June 20, 1969

June 4, 1969

Subject: Advanced Stereo Rhomboid
Reference: Contract [REDACTED]
[REDACTED]

Proposal to Modify
The Prototype
ADVANCED STEREO RHOMBOID

ADVANCED STEREO RHOMBOID
OPTICAL SCHEMATIC
FIGURE 1

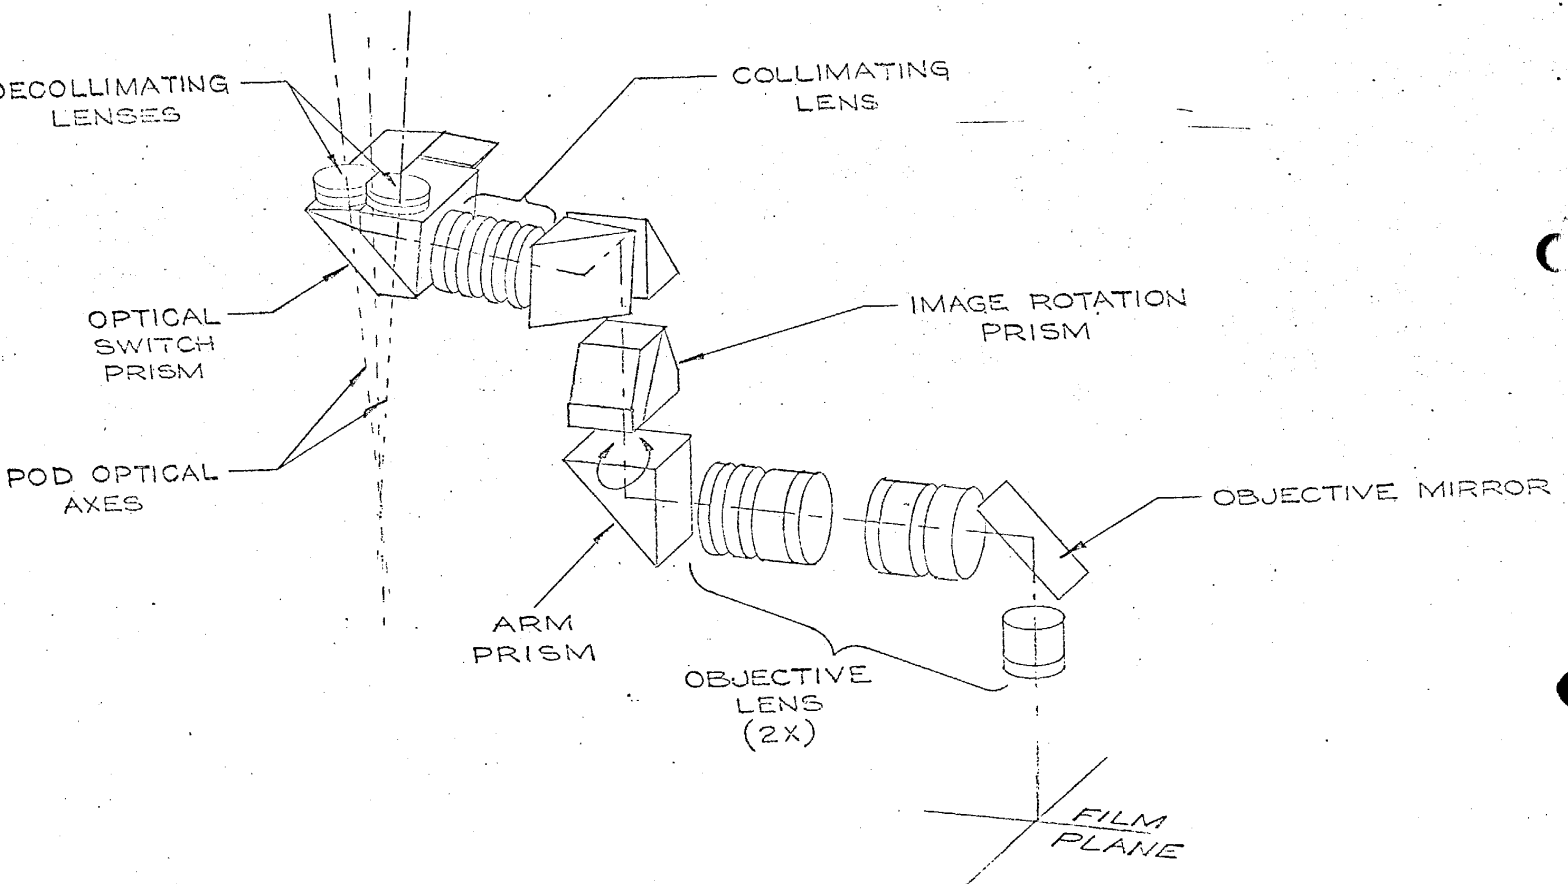
Section 3.0 contains a description of the problems encountered during the alignment of the prototype Advanced Stereo Rhomboid and the effect on the instrument performance. The rework required to correct these problems is described in Section 4.0. See Figure 1 for location of optical components.

3.1.1 A beam divider is required in the optical switch to permit mono-viewing. The beam divider coating on the present optical switch prisms acts as a dichroic coating. That is, the spectral distribution of the reflected and transmitted beam are not identical. The reflected beam is yellowish and the transmitted beam is bluish. The result is that different color is evident in each eyepiece during mono-viewing. In normal production, coatings of this nature are rejected. However, with the prototype Advanced Stereo Rhomboid, only one set of prisms were manufactured which did not permit the normal rejection procedure to be followed.

3.1.2 The optical switch prism, for manufacturing convenience, was coated with the stereo-viewing reflecting surface on one prism and the mono-viewing beam divider on another prism. When the prisms were cemented together, the two coatings were not coplanar, due to wedge in the cement layer. This results in image jump when switching from mono to stereo.

The image jump described above results in phoria and image runout (when rotating the image rotation prism) in two of the switch positions when the instrument is aligned to the third position. A compromise alignment was made with the phoria minimized in stereo position. The resulting compromise was not optimum for image quality in any position.

A new optical switch prism cluster will be manufactured with the following changes. It will be made with closer tolerances on the allowable amount and type of color. The mono-viewing beam divider coating and the stereo-viewing reflection coating will be located on the same surface which will eliminate image jump when switching from stereo to mono viewing.

SCHEMATIC OF THE PROPOSED
SWITCH PRISM ADJUSTING MOUNT

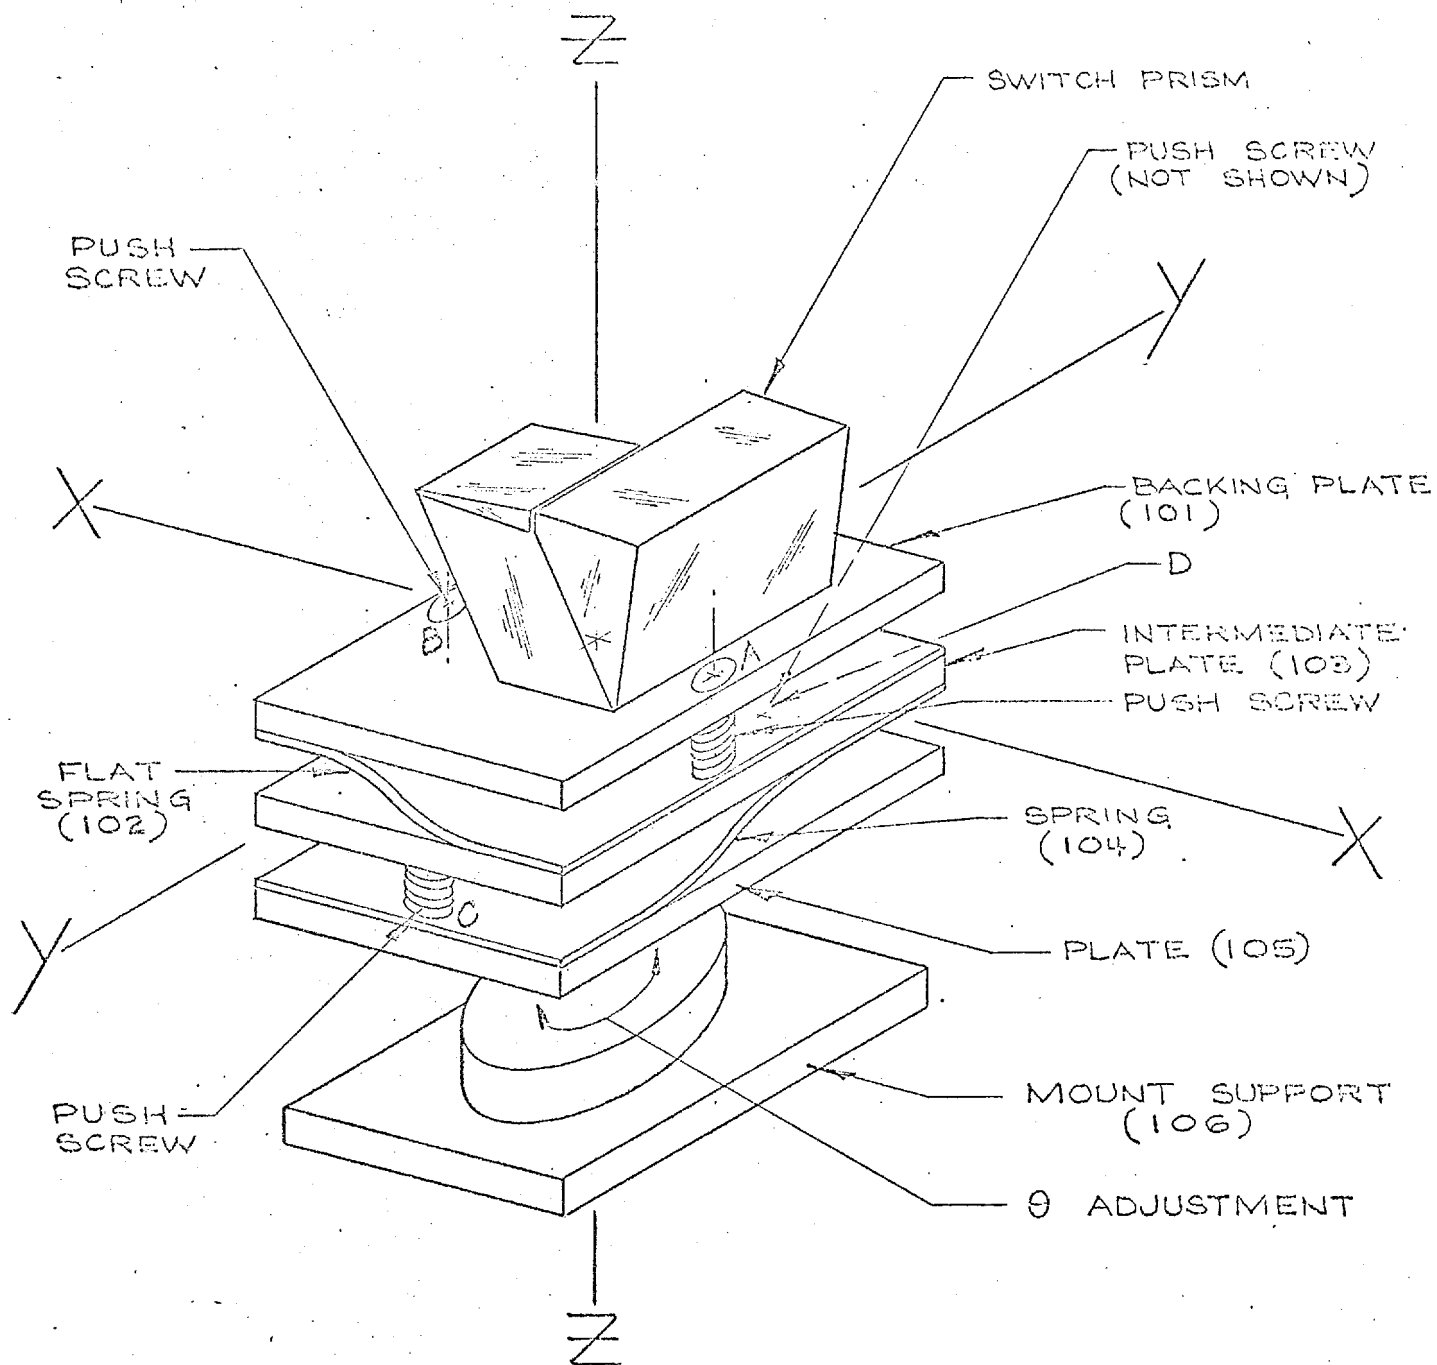
In the present system the optical switch was pre-aligned in a fixture and cemented in its slide mount prior to assembly into the main body. However, it became apparent during alignment, that adjustment of this assembled unit to eliminate normal manufacturing tolerances in the main body casting, was not possible because of interaction between two mono-positions of the switch. It is now apparent that each half of the switch has to be independently aligned while assembled in the main casting to eliminate this interaction.

Redesign of the switch mounting will allow the switch prisms to be independently adjusted while assembled in the instrument.

Mechanically, the changes will consist of relocating the switch way rods, redesigning the carriage to provide an X, Y, Z and θ adjustment of the prism mounts independently and adding a cover plate to the bottom of the housing. The proposed prism adjustment will consist of a compound deflection mount shown in Figure 2. The primary advantages of the deflection mount are inherent stiffness, capability of

adjustment on independent axes; and lateral stability superior to a normal push-pull mechanism.
